**Florida Department of Transportation
REEVALUATION FORM**

- a. Project Phase: Design Change and Advance to ROW Reevaluation
- b. Document Type and Date of Approval: Final Environmental Impact Statement (FEIS) and Section 4(f) Evaluation approved on November 22, 1996; Records of Decision (RODs) approved on January 31, 1997 and June 14, 1999 (See the attached FEIS and RODs, Attachments B-C).

- c. Project Numbers: IR-9999 (43) 258337-1 N/A
Federal Aid WPIS ETDM
- d. Project Name, Location and Limits (from original document): I-275 (SR 93) from the Howard Frankland Bridge/Kennedy Boulevard ramps and just north of Cypress Street on Memorial Highway (SR 60) north to Dr. Martin Luther King Jr. Boulevard and I-4 from I-275 (including interchange) to east of 50th Street (US 41): a multi-lane controlled access facility (Crosstown Connector) on new alignment from I-4 south to the existing Tampa South Crosstown Expressway from the Kennedy Boulevard Overpass to Maydell Drive. Hillsborough County (See the attached FEIS Design Study Segments Map – Attachment D).

3. EVALUATION OF MAJOR DESIGN CHANGES AND REVISED DESIGN CRITERIA (e.g., Typical Section Changes, Alignment Shifts, Right of Way Cha

Figure 2: Proposed Cul-de-Sac at West Arch Street

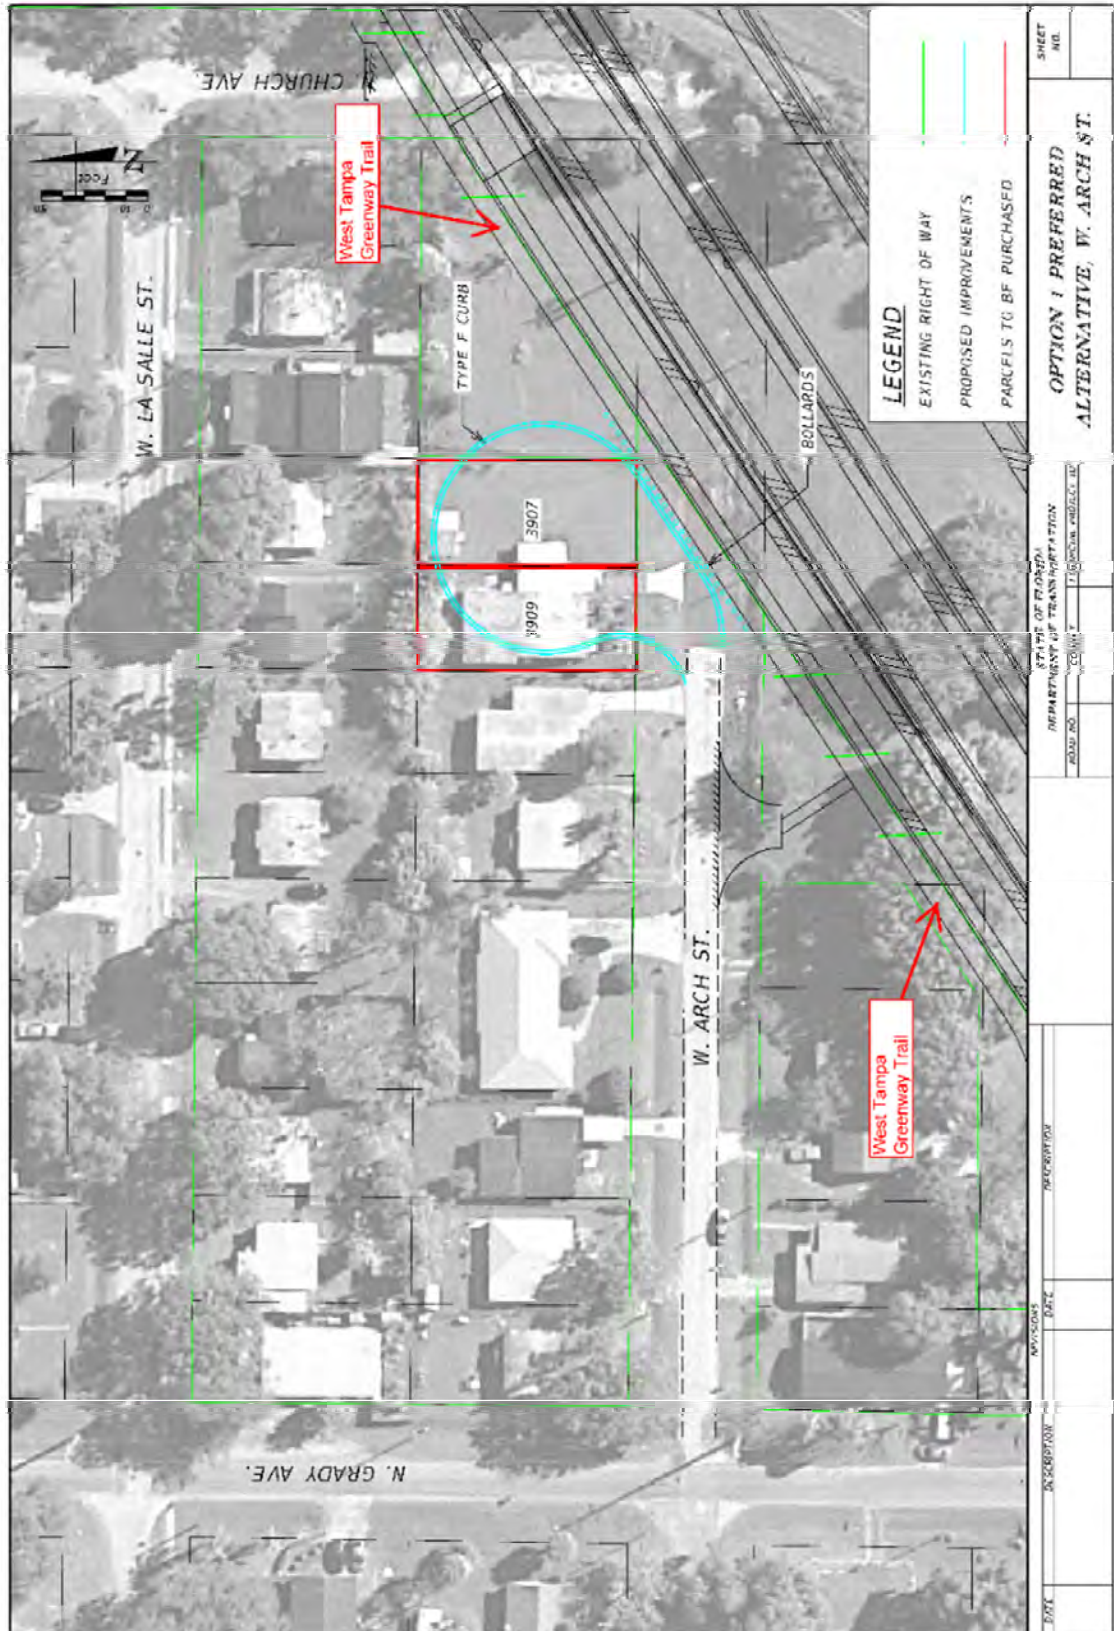
These changes pertain to the future construction of a new cul-de-sac at West Arch Street and a community open space with trailhead at West Grace Street (see Figures 2 and 3). These are currently dead-end streets. The cul-de-sac and community open space will be constructed outside the existing FDOT limited access ROW and will require the acquisition of seven parcels. FDOT has been in coordination with all affected property owners, all of whom are willing sellers. The cul-de-sac will be designed in accordance with the City of Tampa standards for dead-end roads related to fire truck turning movements and Chapter 2 of the American Association of State Highway and Transportation Officials (AASHTO) "*A Policy on Geometric Design of Highways and Streets*" (Green Book). The standards require a 45-foot (ft) radius to complete a safe turn-around for emergency vehicles and city service vehicles such as fire rescue, paramedics and garbage collection vehicles.

The FDOT will purchase the subject parcels, demolish existing structures and grade the disturbed area, sod the area disturbed by the demolition, construct fencing, install lighting, and design and construct the roadway improvements to include the cul-de-sac and permeable parking. FDOT has obtained acknowledgement from the City that the aforementioned commitment is acceptable to the City (see Attachment F).

Figure 5: Proposed Options for West Arch Street Presented at the September 3, 2015 Carver City/Lincoln Gardens Neighborhood Association Meeting

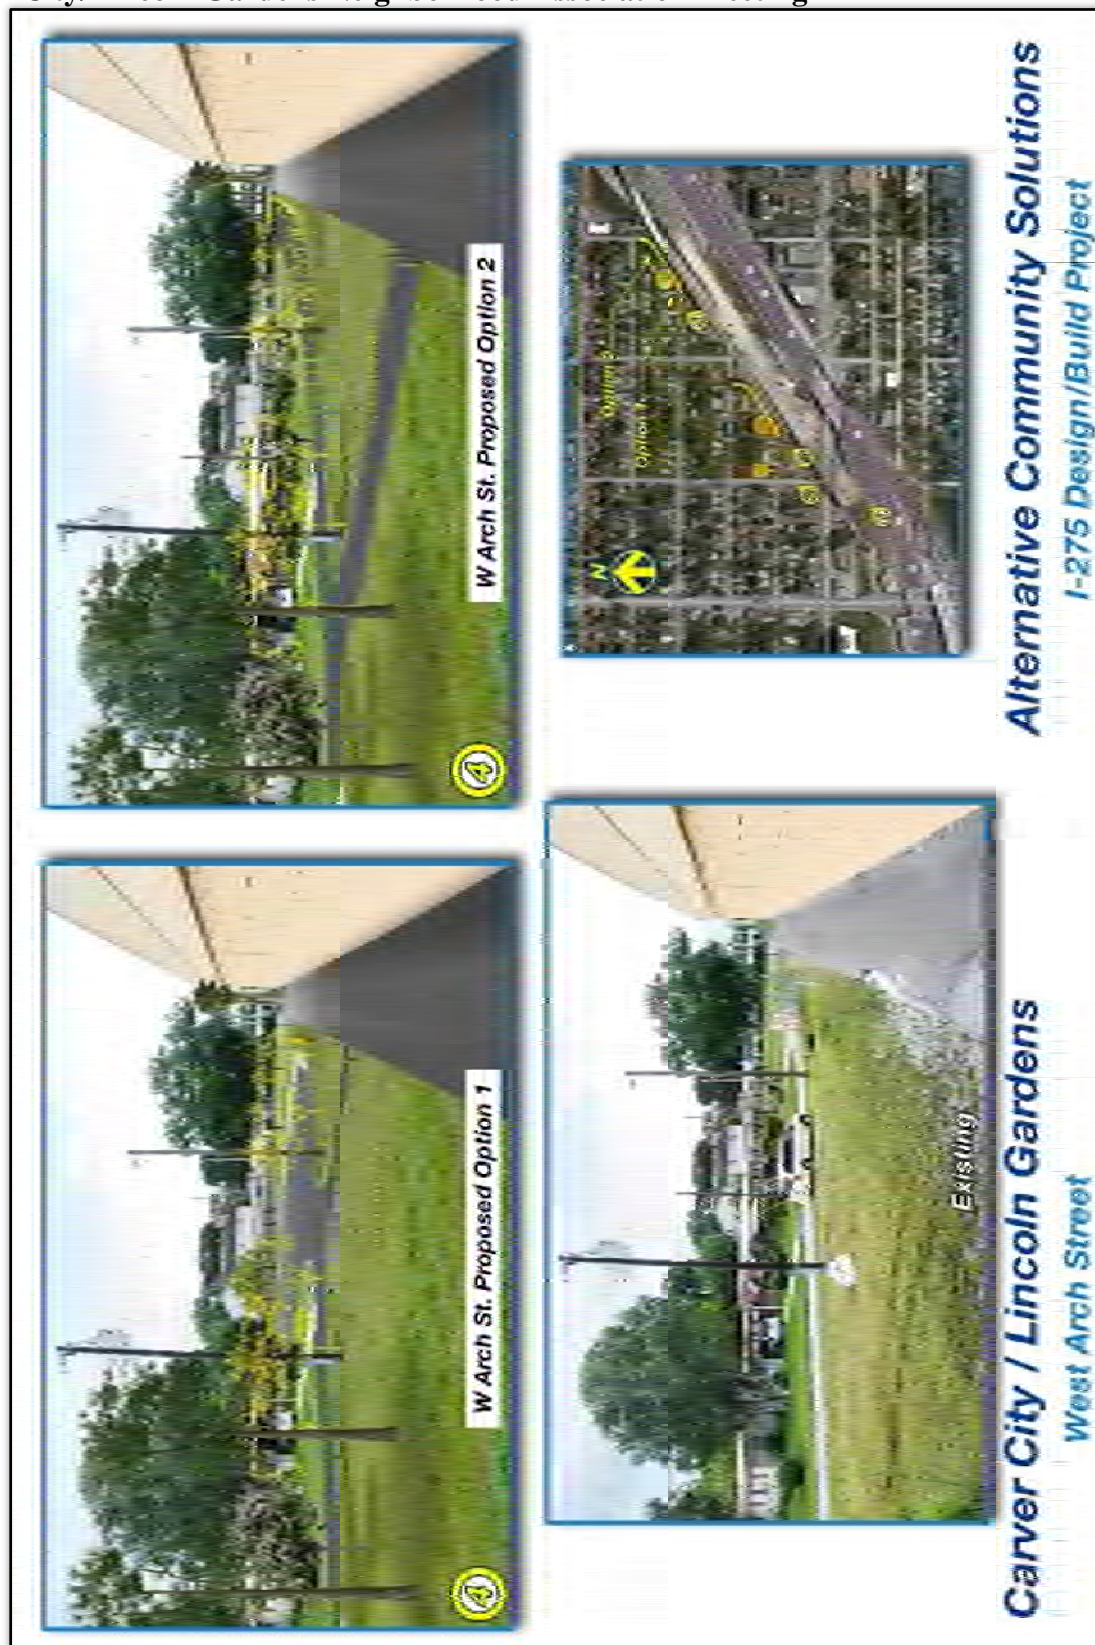
Option 1 (Figure 5) provided a cul-de-sac at the end of the street that can accommodate the turning radius necessary for emergency and service vehicles. This option requires the acquisition of one property (two parcels). Option 2 provided for a connector road between Arch Street and LaSalle Street, and it would acquire two properties.

After a presentation by the FDOT outlining the different Options, the FDOT opened the floor for questions and answers. After discussion, the community chose Option 1 for each location as the preferred alternative. Three individuals gave written comments, and Dr. Harvey, the President of the Carver City/Lincoln Gardens Civic Association, submitted a letter. All property owners are willing sellers. Additional details can be found in the Social and Community Effects Technical Memorandum dated October 2016.
